UNITED STATES PATENT AND TRADEMARK OFFICE

APPLICATION NO.	FILING DATE	FIRST NAMED INVENTOR	ATTORNEY DOCKET NO.	CONFIRMATION NO.
10/783,992	02/20/2004	Giorgio Petratto	ST-10	4371

Office Action Summary	Application No.	Applicant(s)	
	10/783,992	PETRATTO, GIORGIO	
	Examiner	Art Unit	
	Michael P. Ferguson	3679

DETAILED ACTION

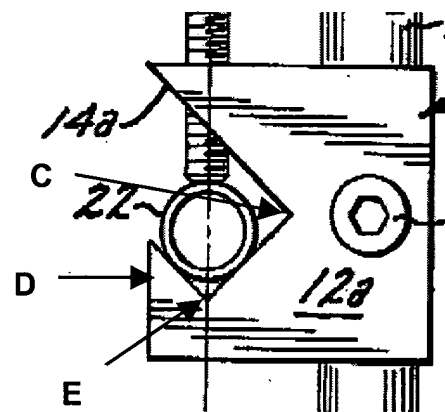
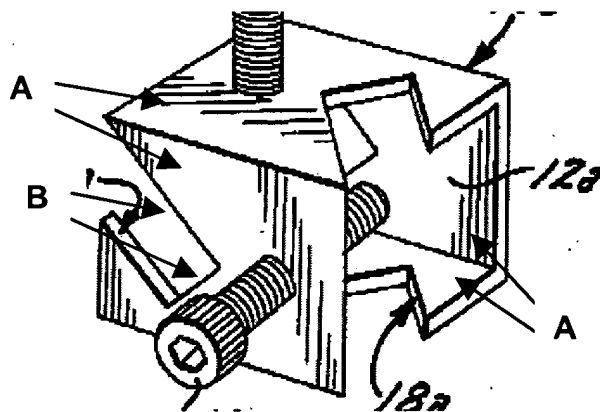
As to claim 1, Mandell discloses a clamp **10a** for connecting bars, and comprising a body defining a pair of prismatic guides for respective bars; and

Means **28,30** for locking the bars inside the guides;

characterized in that the body is defined by four sheet metal plates **A** (Figures 11 and 12 reprinted with annotations below) arranged parallel and facing in pairs of two, and connected substantially along the edges of the body;

the guides each being defined by a pair of aligned seats formed along respective sides of two respective facing plates (Figures 11 and 12).

As to claim 3, Mandell discloses a clamp **10a** characterized in that the plates **A** each have a first and a second opposite side extending along the edges of the body and shaped to fit respectively (adjoin) to complementary sides of the adjacent plates (Figure 11).

As to claim 4, Mandell discloses a clamp **10a** characterized in that the plates **A** are asymmetrically C-shaped, and each comprises two portions **B** of different lengths extending from opposite sides of the seat;

the seat being defined by a back edge **C** and by respective inner edges of the portions (Figure 12).

As to claim 5, Mandell discloses a clamp **10a** characterized in that the longer of the portions **B** terminates with (faces) a tooth **D** (on shorter portion **B**) facing inwards of the seat and having a side separated from the back edge **C** by a distance equal to the length of a first side of the respective bar, and an end surface separated from the inner edge **E** of the other (shorter) portion by a distance at least equal to the length of a second side of the bar (Figure 12).

As to claim 6, Mandell discloses a clamp **10a** characterized in that the plates **A** are identical in each pair of two (Figure 11).

As to claim 7, Mandell discloses a clamp **10a** characterized in that the two identical plates **A** of each pair are adjacent to each other, with the relative seats on opposite sides of the body (Figure 11).

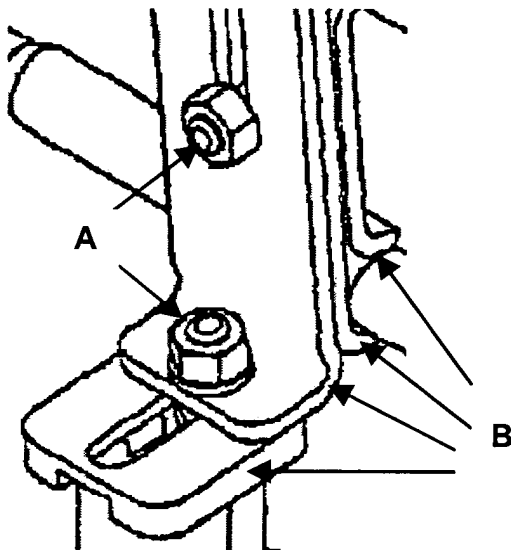
As to claim 1, Csiki et al. disclose a clamp 7 for connecting bars, and comprising a body defining a pair of prismatic guides for respective bars; and

Means A (Figure 1 reprinted below) for locking the bars inside the guides; characterized in that the body is defined by four sheet metal plates B arranged parallel and facing in pairs of two, and connected substantially along the edges of the body;

the guides each being defined by a pair of aligned seats formed along respective sides of two respective facing plates (Figure 1).

As to claim 3, Csiki et al. disclose a clamp **7** characterized in that the plates **B** each have a first and a second opposite side extending along the edges of the body and shaped to fit respectively to complementary sides of the adjacent plates (Figure 1).

As to claim 8, Csiki et al. disclose a (packaging) machine (capable of packaging graphics) comprising:

- a supporting structure **1**;

- a conveying surface (inherent; not shown) capable of successively conveying blanks; and

- a number of tools (inherent, support rail **1** and brackets **7** are assembled using tools; not shown) connectable to the supporting structure, over (the length of) the conveying surface, by means of a number of bars **2,3,5,6**;

- a number of clamps **7** for connecting the bars, each clamp comprising a body defining a pair of prismatic guides for respective bars; and

- means **A** for locking the bars inside the guides;

- characterized in that the body is defined by four sheet metal plates **B** arranged parallel and facing in pairs of two, and connected substantially along the edges of the body;

- the guides each being defined by a pair of aligned seats formed along respective sides of two respective facing plates (Figure 1).
